The Commission has issued the enclosed Amendment No. 14 to Provisional Operating License No. DPR-22 for the Monticello Nuclear Generating Plant. This amendment includes Change No. 22 to the Technical Specifications and is in response to your requests dated March 12, 1975 (except for items 3 and 4 thereof), and August 4, 1975, and other filings by you dated August 20, 1974, July 9, 1975, July 10, 1975 (except for that portion dealing with APRM flux scram trip setting and rod block equations), July 24, 1975 and September 16, 1975.

MONTICELLO NUCLEAR GENERATING STATION

Amendment No. 14
License No. DPR-22

CHANGE NO. 22 TO THE TECHNICAL SPECIFICATIONS

Figure 3.11.1-E
Maximum Average Planar Linear Heat Generation Rate Versus Planar Average Exposure
Monticello 8D219 Fuel

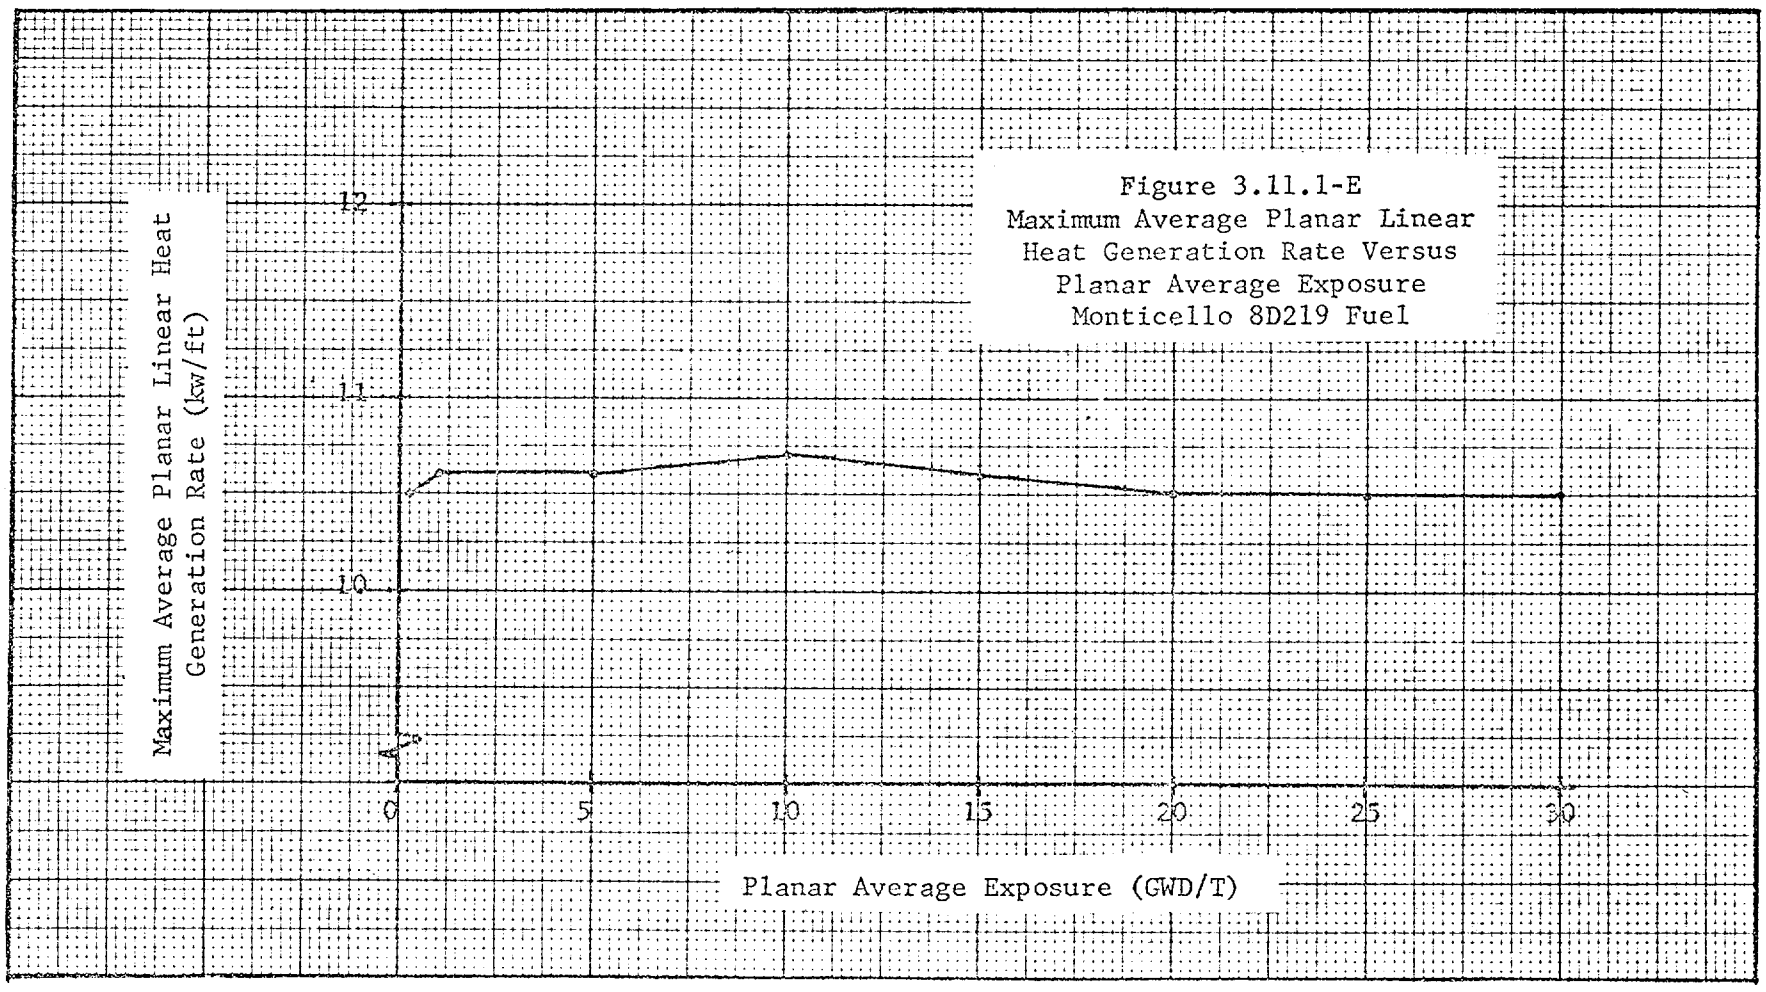
During steady state power operation, the APLHGR for each type of fuel as a function of average planar exposure shall not exceed the limiting value shown in Figures 3.11-1. If at any time it is determined that the limiting value for APLHGR is being exceeded, action shall be taken immediately to restore operation to within the prescribed limits. This occurrence shall be reported to the Office of Nuclear Reactor Regulation within 30 days of the date of occurrence.
